Notice of Intent

Type of Action: APD Change

Procedure Description: Devon Energy Production Co., L.P. (Devon) respectfully requests a change to the drilling plan for the Morgan 25-13 Fed Com 306H, 716H & 736H to include break test variance with stump testing . Attachment included.

PECOS DISTRICT DRILLING CONDITIONS OF APPROVAL

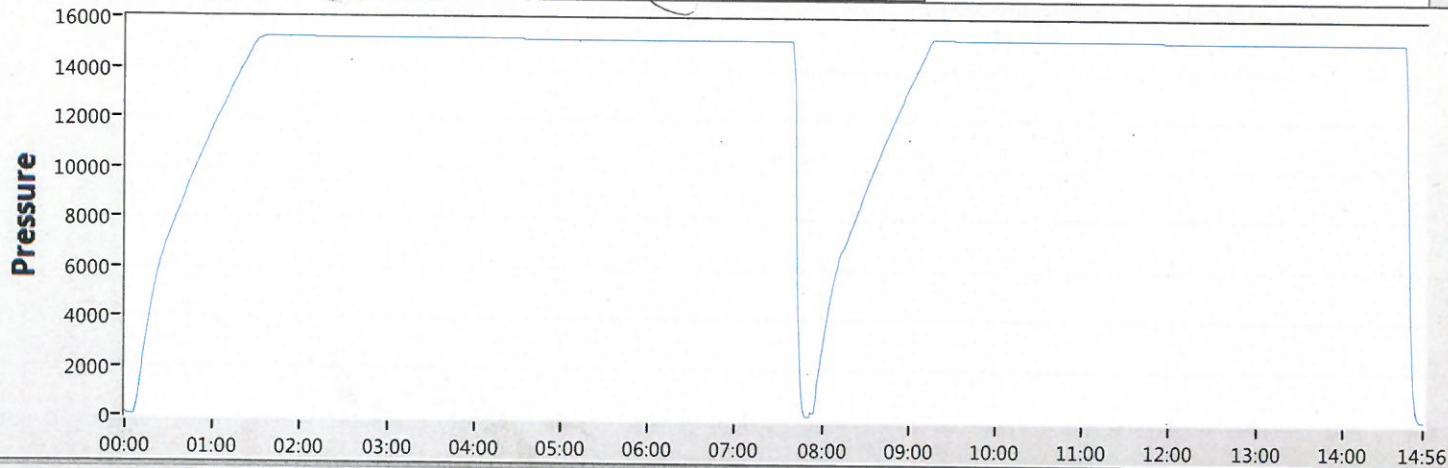
Devon Energy requests to perform offline BOP stump testing and offline BOPE testing. All pressure-containing and pressure-controlling seals will be tested either online or offline as denoted in the table below and per BLM approval during initial BOP test following test pressure requirements set forth in 43 CFR 3172. Remaining components not tested offline or on the stump will be tested within 72-hours when the BOP is connected to the wellhead. If stump testing exceeds 72-hour window prior to connecting to the wellhead, the BLM will be notified and either stump testing restarted, or the BOP being tested online. The BLM will be contacted 4hrs prior to a BOPE test. The BLM will be notified if and when a well control event is encountered. In the event stump testing is not utilized, then a full BOPE test would be conducted.

Components	Offline	Offline, BOPE	Break	Online
Upper Rams		X	X	X
Blind Rams		X		X
Lower Rams				X
Outside Kill Valve		X	X	X
Inside Kill Valve		X	X	X
Kill Line Check Valve		X	X	X
Inside Choke Valve		X	X	X
HCR		X	X	X
Kill Line	X			X
Annular		X		X
Choke Manifold Valves and Hose	X			X
Mudline (Mud Pumps, Rig Floor Valves, Kelly Hose, Mud Line)	X			X
Standpipe Valve	X			X
IBOP (Upper and Lower)	X			X

Devon requests offline BOPE testing for the following components: Upper Rams, Blind Rams, Kill Valves, Choke Valves, and Annular

Devon requests Break testing as stated above for 5K tests, not including production hole

Annular Preventer will be tested to minimum of 70% RWP and higher than MASP during initial BOP test

Pressure testing is required for pressure-containing connections if the integrity of a pressure seal is broken during a break test

Full Tests required when entering production hole
